**Town of Hilton Head Island**  
**Design Review Board Meeting**  
**Tuesday, September 27, 2022 – 1:15 p.m.**  
**REVISED AGENDA**

## Town of Hilton Head Island Design Review Board Meeting

## DESIGN TEAM/DRB COMMENT SHEET

## BILLY WOOD APPLIANCE

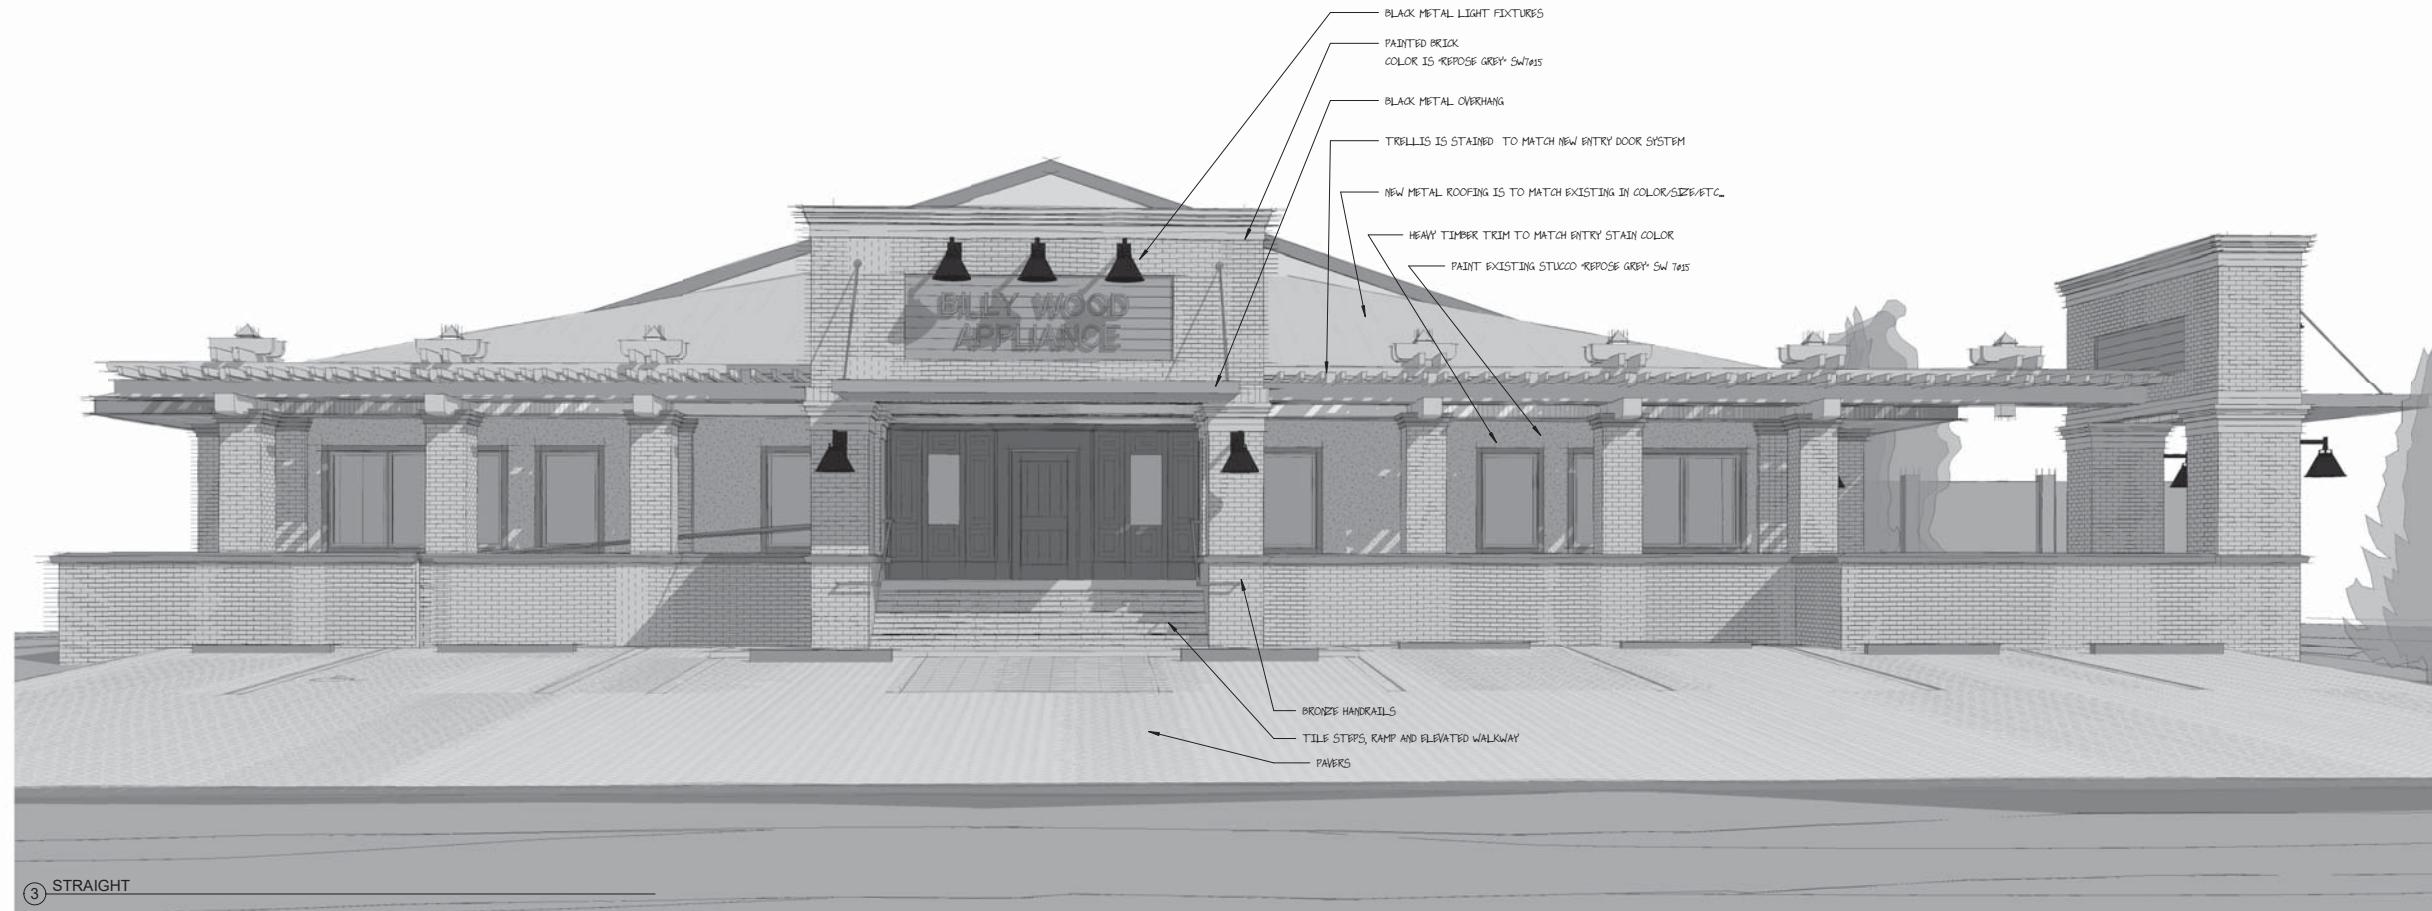
The Board questioned the size of the screening fence on the left of the building and its purpose in the project. They felt the fence is too tall, and the Board recommends it be shortened or matched to the height of another element in the project.

The Board stated the black paint proposed is not a color which fits within the design guidelines and a dark brown or brass replacement is recommended. The Board also recommended the addition of plants in front of the fence to assist with the fence blending into the background.

The applicant stated that the color of the rendering was not in line with the current plan and showed the Board an updated color sheet. The Board noted that the updated grey color was appropriate and well chosen for the project. The applicant stated that they would be open to painting the window frames a dark bronze to match the lighting and railing elements.

The Board recommended that the applicant consider something other inkberry which is more suited to planters. Additionally, the board recommends the applicant reconsider the foundation planting on the right side of the building.

In addition to the concerns with the presented project, the Board stated that they would like additional details to be added for the brick façades, brick plasters, and connection of the roof to the front façade.

1. Provide a detail for the brick pilasters.
2. Provide a detail for the connection of the roof to the front entrance façade.
3. Provide more architectural detail on the brick facades.
4. The right side façade should be architecturally connected to the building or eliminated from the project.
5. Consider enlarging the monument sign and eliminating the right side façade.
6. Study reducing the height of the fence at the handicapped ramp.
7. The back service yard fence and columns should be painted a dark color.
8. The back service yard fence should be screened with shrubs.
9. Specify a different shrub for the Inkberry better suited for planters.
10. Reconsider the foundation planting on the right side of the building.
11. The Board supported the alternate building color scheme presented at the meeting by the applicant.
